Consultant	Wahib Medanat Consultant Engineer	Rep No.	12-17102021
Contractor	Derar Saraireh & Sons for Engineering & Contracting	Tender No.	(11/2019/USAID/SKEP/3/S) Schools for a Knowledge Economy Project (SKEP) - Phase (3) Package (1, 2)
Site Name	Al Khansa' Basic Mixed School- Al Balqa	Day/ Date	Sun. 17/10/2021
Duration of Project	450 Calendar Days	Total Project Budget	9,789,417.840 JD

Visit Notes

(Figures: 05 & 06)

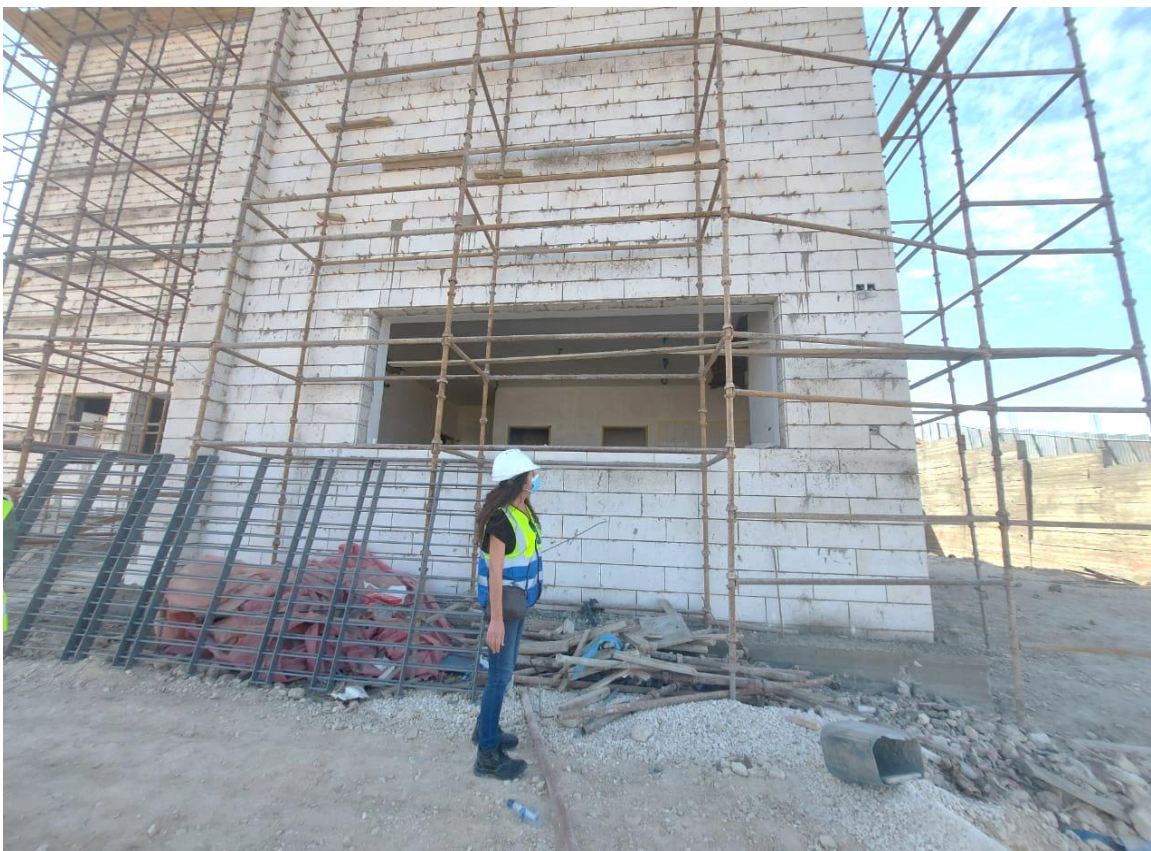
The supervision team inspecting the Insulation and backfilling works
